**GEORGETOWN-SCOTT COUNTY PLANNING COMMISSION
AGENDA**

**August 13, 2015
6:00 p.m.**

CNG FUEL STATION
Staff Report to the Georgetown-Scott County Planning Commission
August 13, 2015

GOLF TOWNHOMES OF CHERRY BLOSSOM, PHASE 5
Staff Report to the Georgetown-Scott County Planning Commission
August 13, 2015

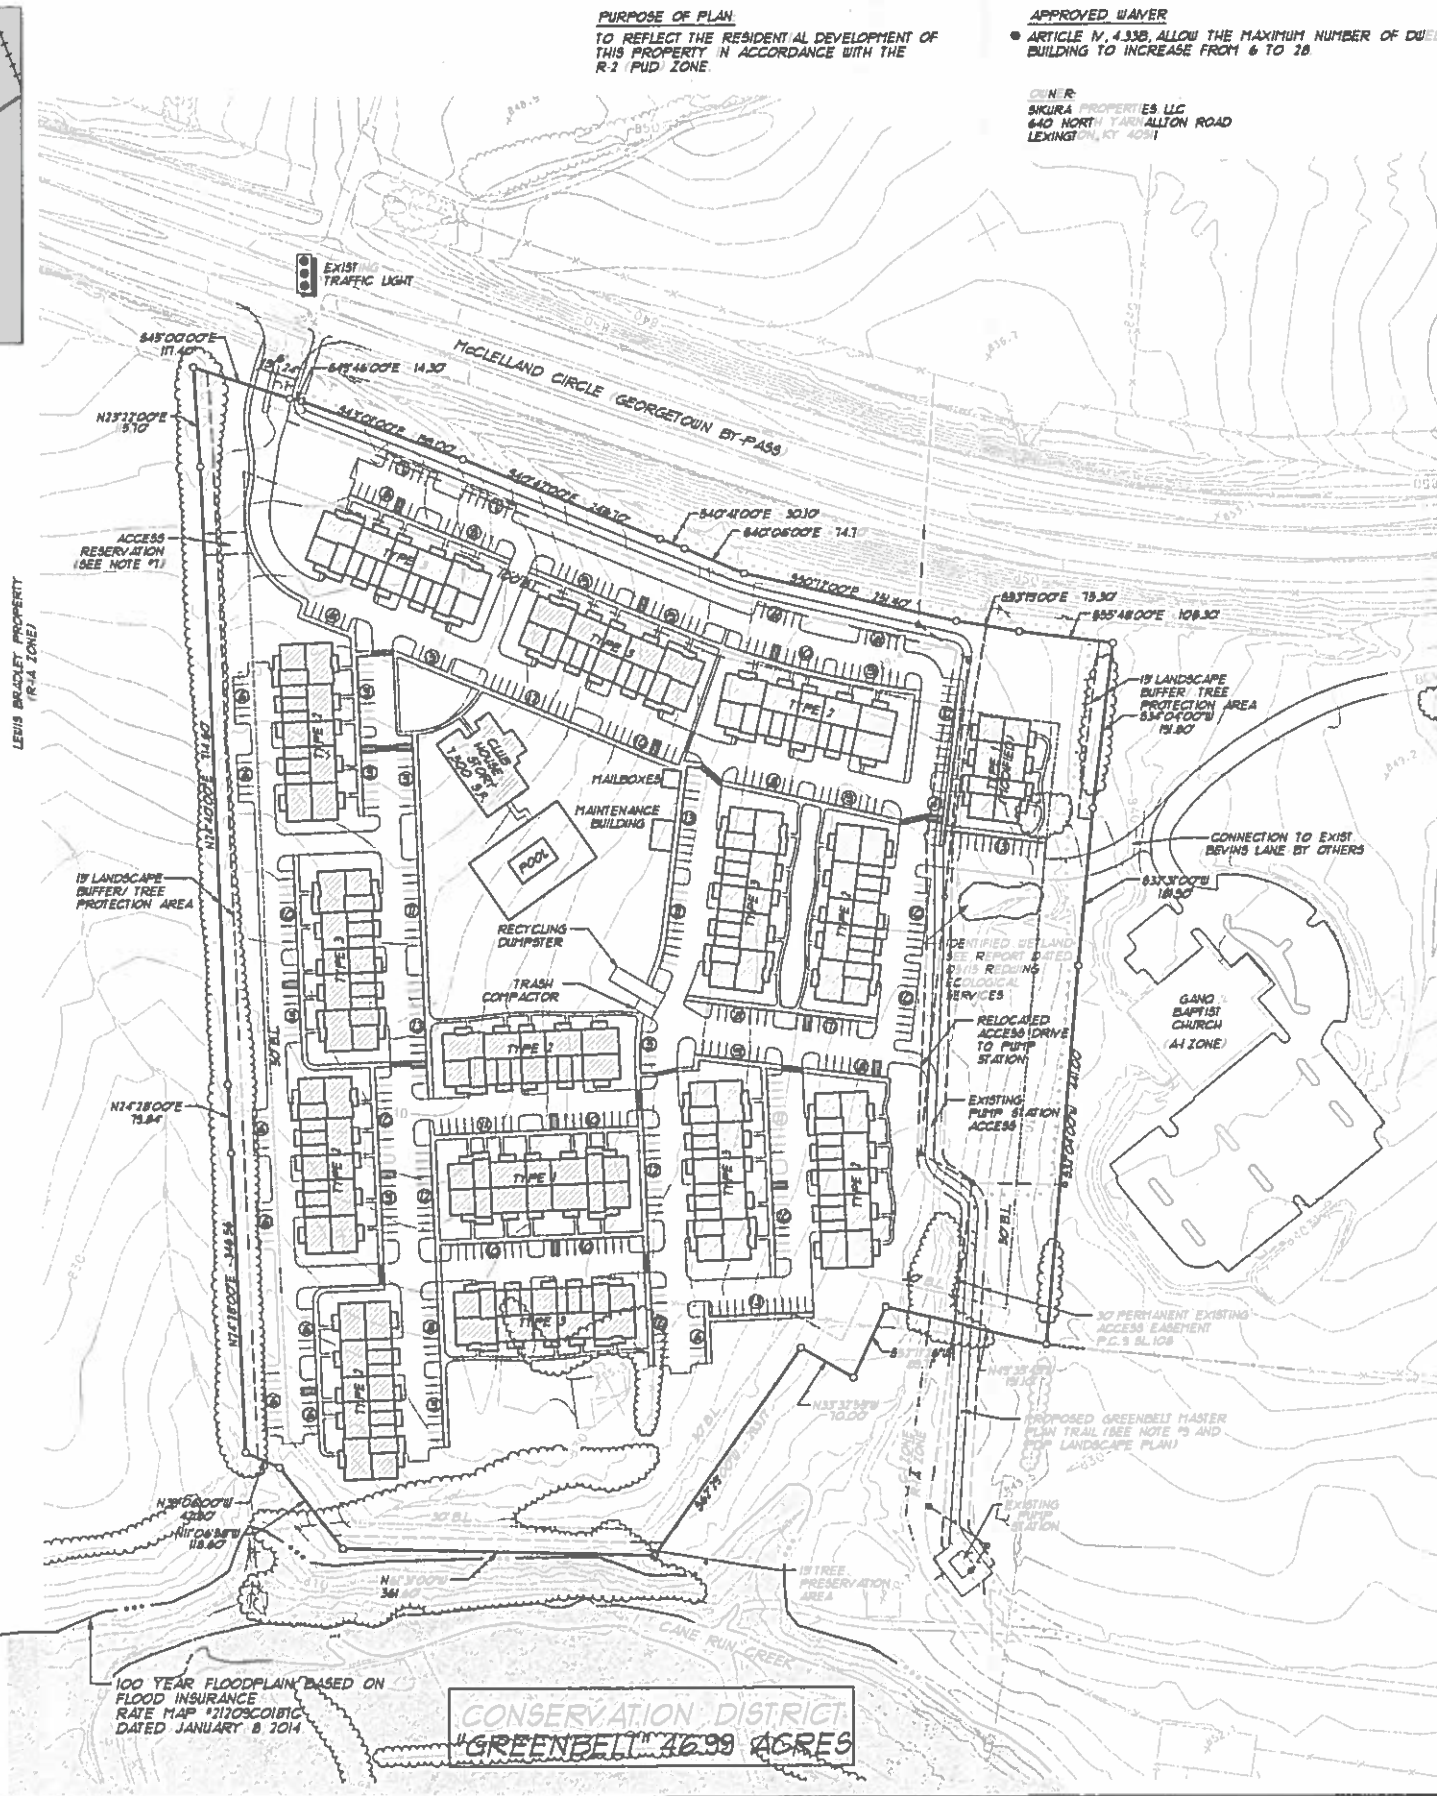
Sidewalks have been provided throughout the development to provide pedestrian circulation. Staff proposes that the central walk could be expanded from 6 feet wide to 8 feet in order to accommodate the multi-use trail discussed in the previous zone change applications.

The Applicant has shown a potential multi-use trail location located partially on-site (east border) and partially off-site (north border) with this new Preliminary Development Plan submission. Staff believes there are two options that would satisfy the original intent of discussions regarding connection of the proposed trail between the greenbelt and the signalized intersection at McClelland Circle:

- 1) Build the multi-use trail as part of this development. This can be accomplished by expanding the existing pedestrian infrastructure included on this plan. The 6-foot wide sidewalk shown along the entrance, north and east edges of the pool and common area, and then extending south through the parking lots could be expanded to an 8-foot wide multi-use trail.
- 2) The proposed location as shown by the Applicant could be clarified and used to designate location for future development. In this case, staff recommends that the entire trail be located on site rather than through McClelland Circle right-of-way. Additionally, provision of an easement, rather than intent to establish an easement will provide more clarity and expedite the process for any future grant application of City-funded work.

Staff requested a landscape plan to review, but none has been provided. It will be necessary for a thorough review of the landscaping plan at the time of Final Development Plan approval to ensure that the property buffering, vehicle use area, and canopy standards have been met. The Applicant will be required to show appropriate tree preservation to meet the requirements of the *Greenbelt Ordinance* and/or appropriate landscape buffers to satisfy the *Landscape and Land Use Buffer Ordinance* and the *Subdivision & Development Regulations*.

1. All applicable Conditions of Approval from Zone Change ZMA-2015-07 and ZMA-2012-14.
2. The zoning for the Bradley Property to the west of the parcel will be updated to A-1.
3. A landscape plan/tree protection plan meeting the requirements of the newly amended *Landscape Ordinance* will be required before the Final Development Plan is approved, including:
 - a. Preservation of existing tree lines along the western property line and along the Southern Greenbelt (Further detail in ZMA-2012-14 COA),
 - b. Greenbelt buffering, Property Perimeter buffering, Arterial Road buffering along the Bypass,
 - c. VUA landscaping, including the amended interior tree requirements (1 tree per 250 SF of VUA), and the
 - d. New canopy requirements (15-20% based on breakdown of preserved and new tree canopy).

6. The Applicant shall provide an 8' wide multi-use trail connection for non-motorized traffic from the Greenbelt to the McClelland Circle intersection.

- a. This trail will be constructed as part of the development of this site, by the developer, and an easement will be shown for public access on this plan, as well as the Final Subdivision Plat, FSP-2015-24.
OR

- b. A ____-foot wide easement will be shown on the project site for the Final Subdivision Plat of FSP-2015-24 for the future construction of a multi-use trail connecting the Southern Greenbelt to the traffic signal at McClelland Circle. Location per discussion at the Planning Commission hearing. This easement will also be shown on the Final Development Plan for reference.
